Part: SE120-002 / PPPL NCSX VVSA

Problem: Thermal cycle

Nonconformance Report: Major Tool NC19232

Photo added by M. Viola for clarification (Note boxed region of 3 pads):

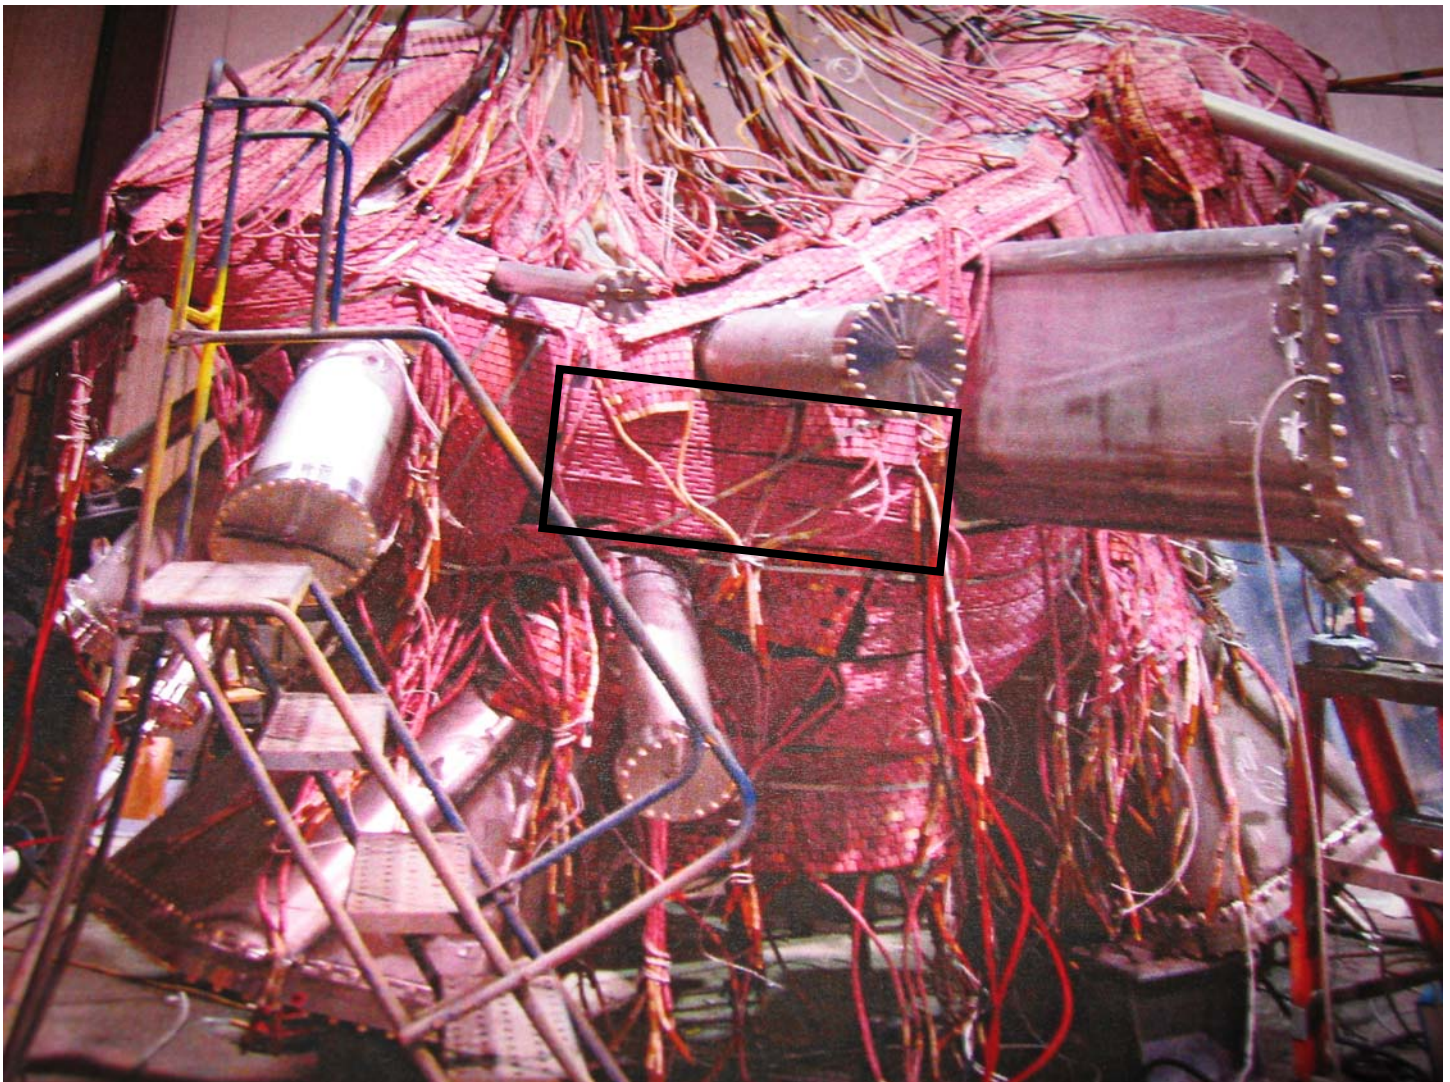
1. During vessel ramp up: One zone (approximately 12 x 29") reached 524F while the rest of the shell was at about 314F. This exceeds the 90 Deg. F maximum temperature gradient (by 130F) allowed during the cycle. Located from the tangent of the large radius of port 12 towards the center region between ports 5 and 7.
2. During port ramp up Port 7W reached 320F (9F above high limit)
3. During port ramp up, Port 11W reached 333F (22F above high limit)
4. During port soak, Port 10E temperature increased to 555F (244F above high limit). The port was above the high limit of tolerance approximately 45 minutes.

We acknowledge the thermal cycle deviations and based on the information received so far, project disposition is use-as-is. However, this disposition will need to be revisited if damage from the heat excursions is detected.
